## ADDENDUM

**ADDENDUM NO.:** 03  
**PROJECT NAME:** CIP Central Hearing Facility Roof and MEP Upgrades  
**PROJECT NO.:** 04044  
**CONTRACT NO.:** C1606  
**DATE OF ISSUE:** December 29, 2023

### NOTICE OF CHANGES, MODIFICATIONS, OR CLARIFICATIONS TO CONTRACT DOCUMENTS

PBC Project Name: CIP - Central Hearing Facility Roof and MEP Upgrades  
PBC Contract No: C1606  
Project No: 04044  
Title  
**WEST ROOF DEMOLITION PLAN**  
Sheet  
**ARD-101**

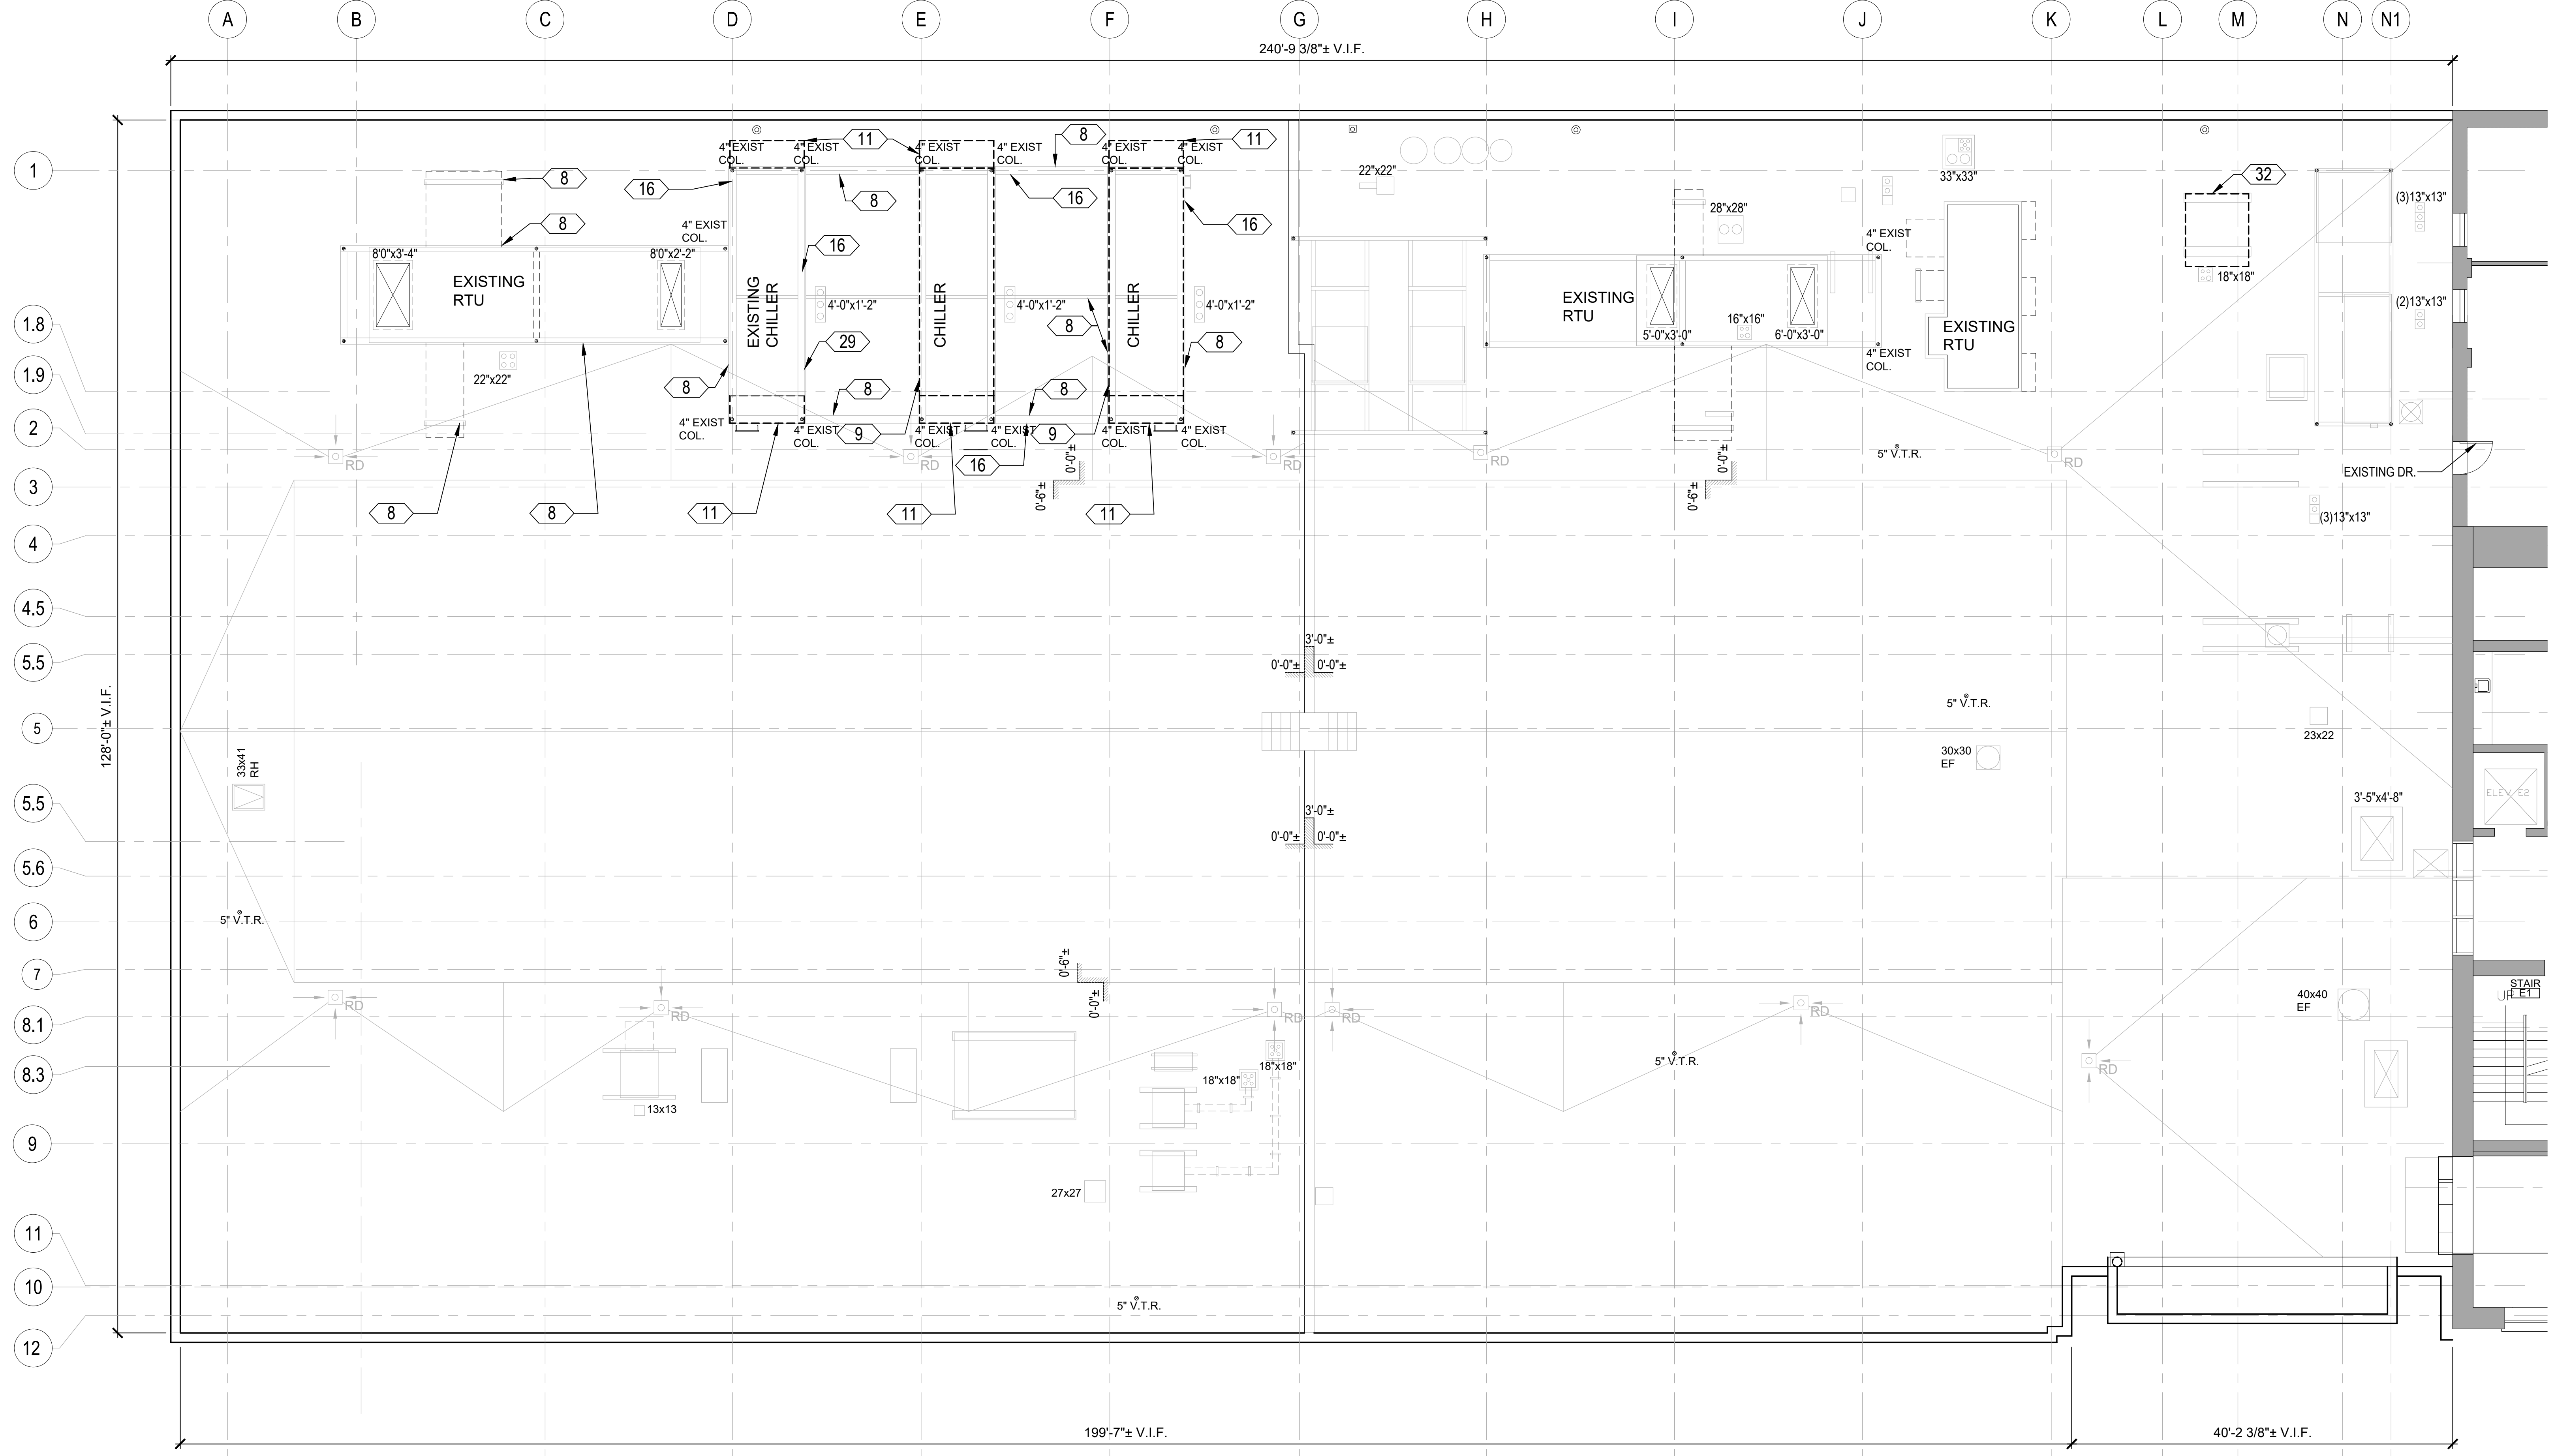
**Change 3** Drawing No. ACD-102E – **REVISED** sheet to add 1 keynote, dated 12.29.23  
**Change 4** Drawing No. ARD-101 – **REVISED** Key Note 5, dated 12.29.23

PBC Project Name: CIP - Central Hearing Facility Roof and MEP Upgrades  
 PBC Contract No: C1606  
 Project No.: 04044  
 Title: **FOURTH & SIXTH FLOOR ROOF DEMOLITION PLANS BASE BID**  
 Sheet: **ARD-102**

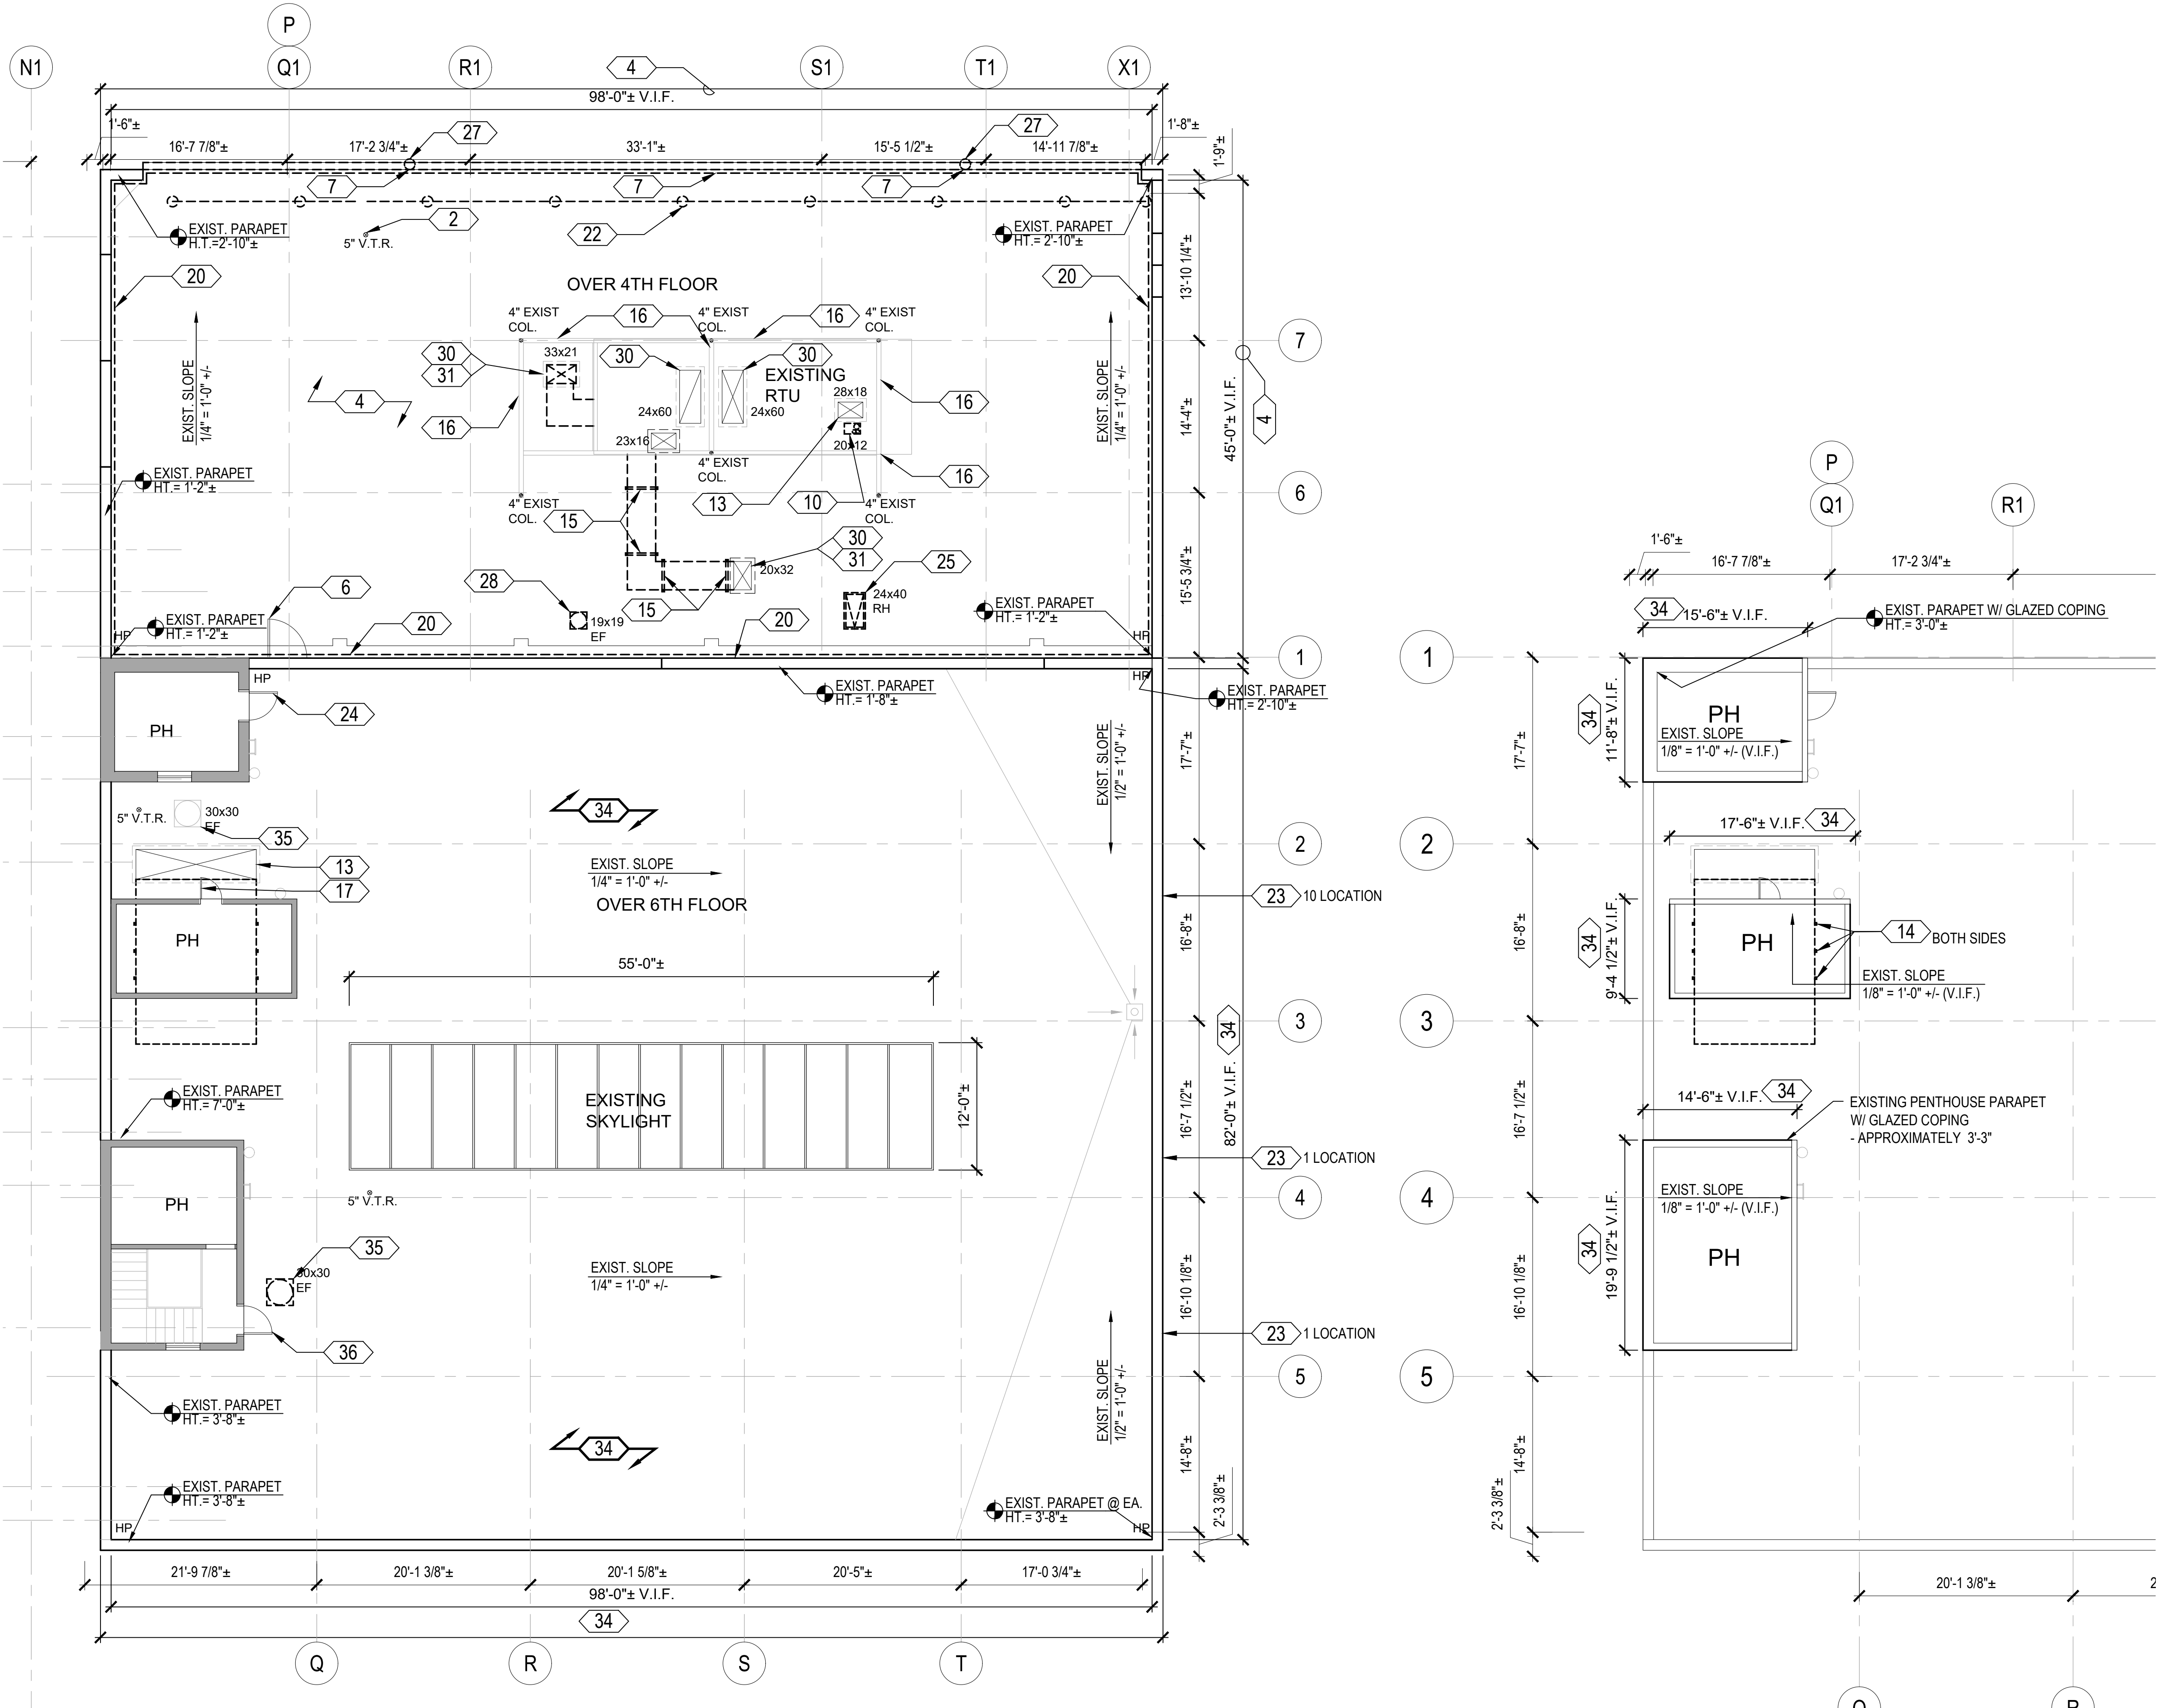
**Change 5** Drawing No. ARD-102 – **REVISED** Key Note 5, dated 12.29.23  
**Change 6** Drawing No. ARD-102A – **REVISED** Key Note 5, dated 12.29.23
